Extending Power via MDI for IEEE 802.3BT, BASELINE

v3.v6

To extend the existing PoE TLV to encompass IEEE 802.3BT additions.

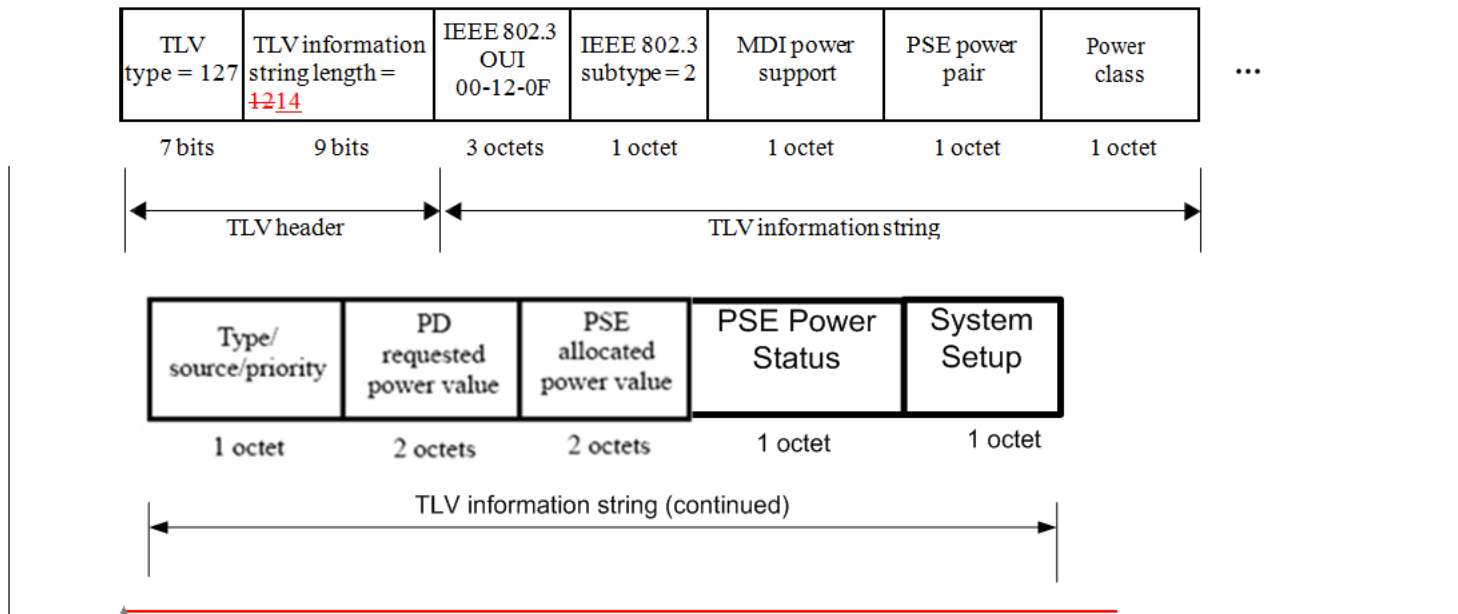
[State diagrams do not need to be changed.]

[TLV length changed from 12 to 14 and two more octets were added.]
